Date: January 18, 2016
Client: Debra Dockery Architects
Project Name: Hangar 9 Renovations
Project Number: 14-073

END OF ITEMS FOR ADDENDUM # 2
(Refer to attached (12) 8-1/2" x 11" drawings)

PARTIAL ELECTRICAL SITE PLAN - NEW WORK

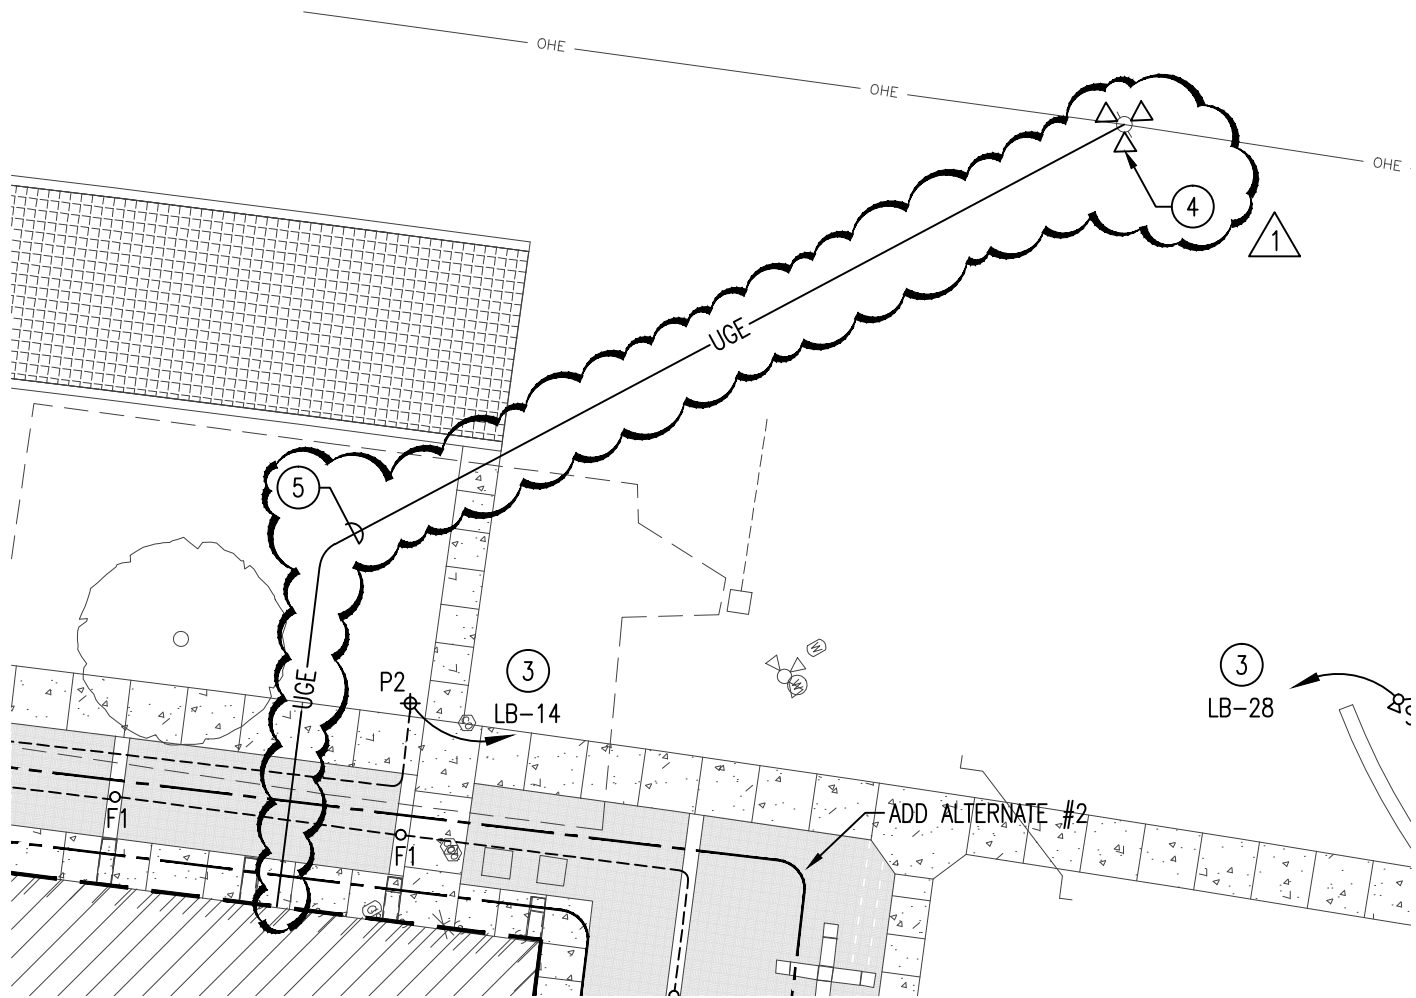
RE: Plan Sheet ES1.1:

- Item 1: Electrical Site Plan revised to show electrical service from existing CPS Energy pole to building.
- Item 2: Keyed Notes – Added Keyed Notes 4 and 5.

1. CONNECT NEW POST LIGHTS TO EXISTING UNDERGROUND CONDUIT.
2. IN-GROUND LINEAR LED FIXTURES. REFER TO DETAIL 3/E4.1 AND LIGHT FIXTURE SCHEDULE FOR MORE INFORMATION.
3. ROUTE EXTERIOR LIGHTING CIRCUIT THRU LIGHTING CONTROL PANEL. REFER TO DETAIL 7 ON SHEET E4.1 FOR MORE INFORMATION.
4. NEW POLE MOUNTED TRANSFORMERS ON EXISTING CPS ENERGY POLE.
5. FURNISH AND INSTALL 2" U.G. CONDUIT WITH PULL STRING PER CPS ENERGY STANDARDS.

PARTIAL LIGHTING FLOOR PLAN - NEW WORK

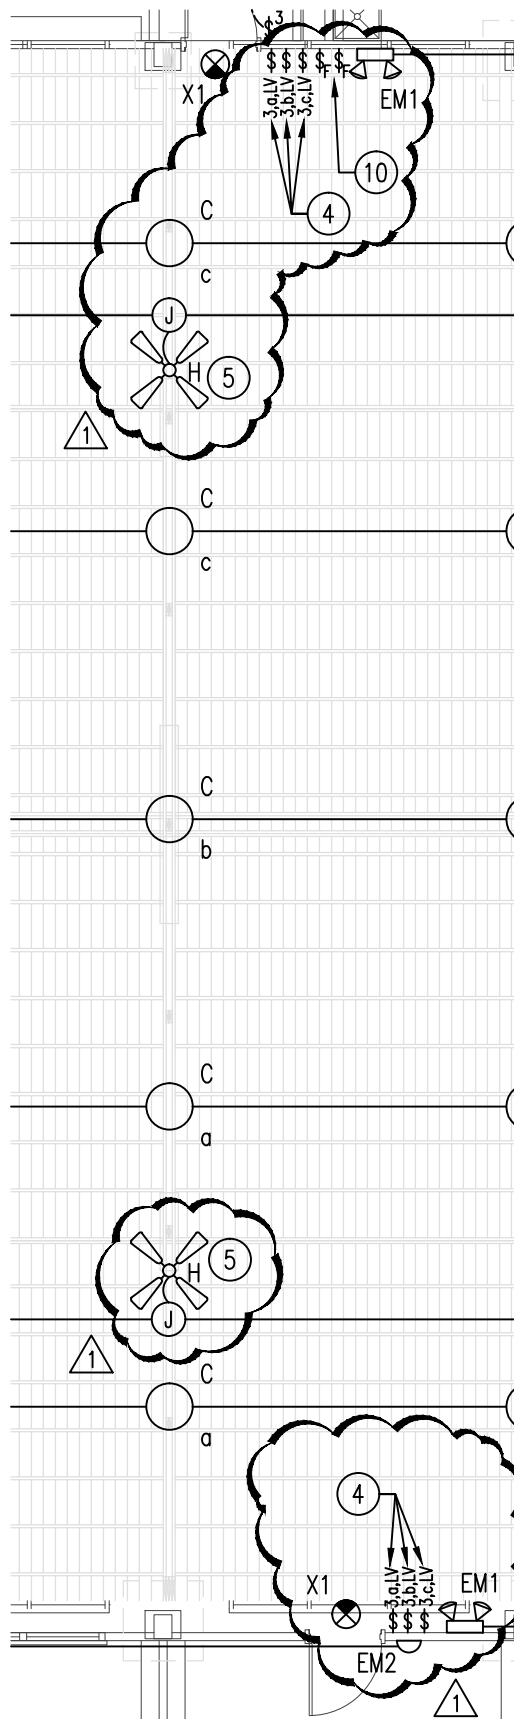
RE: Plan Sheet E1.1:

- Item 1: Revise lighting control switching banks.
- Item 2: Add fan control switches.
- Item 3: Add Type 'H' designation to ceiling fans, typical of all fans.
- Item 4: Keyed Notes – Revise Keyed Note 5
- Item 5: Keyed Notes – Add Keyed Note 10.

5. BELT DRIVEN CONTEMPORARY STYLE CEILING FAN. REFER TO LIGHTING FIXTURE SCHEDULE FOR MORE INFORMATION.

10. FURNISH AND INSTALL A FAN SWITCH TO CONTROL EACH ROW OF CEILING FANS

ENLARGED PARTIAL POWER FLOOR PLAN - NEW WORK

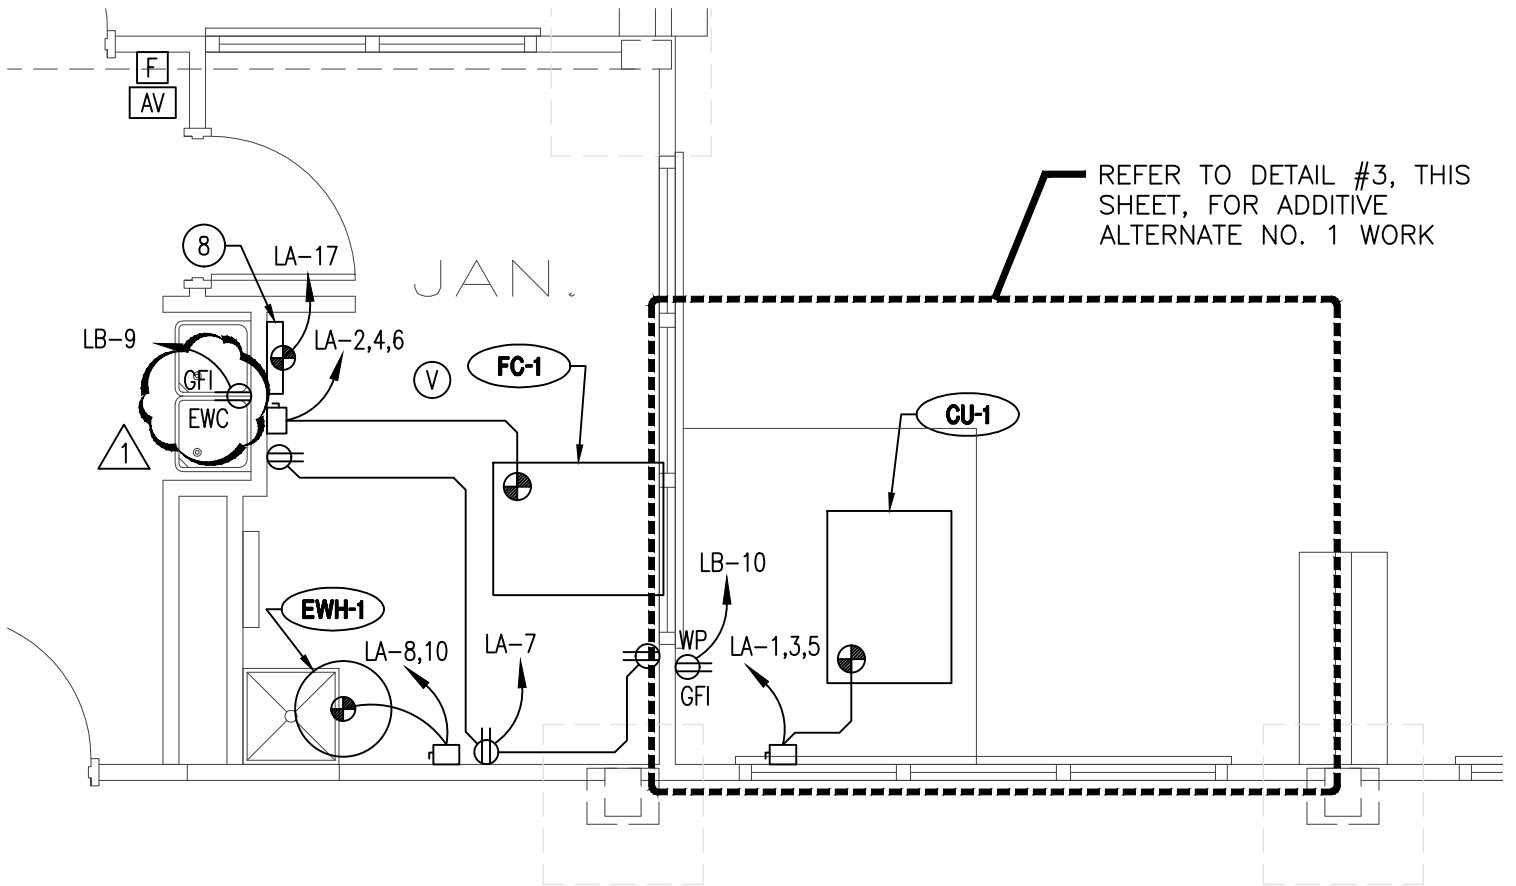
RE: Plan Sheet E2.1:

- Item 1: Receptacle serving EWC shall be GFI protected.
- Item 2: Keyed Notes – Revise Keyed Note #7.
- Item 3: Keyed Notes – Add Keyed Note #9.

7. CPS ENERGY METER LOCATION. CONTRACTOR SHALL INSTALL 2" U.G. CONDUIT FROM METER TO CPS ENERGY TRANSFORMER POLE. REFER TO ES1.1 FOR ADDITIONAL INFORMATION.

9. FLOOR BOX POWER CIRCUITRY SHALL BE ROUTED IN HANGAR FLOOR SLAB AND PASS UNDER EXISTING CONCRETE PERIMETER BEAM SEPARATING HANGAR SPACE FROM LEAN-TO SPACE. EXISTING LEAN-TO CONCRETE FLOOR SHALL BE SAWCUT FOR CONTINUED ROUTING OF CIRCUITRY.
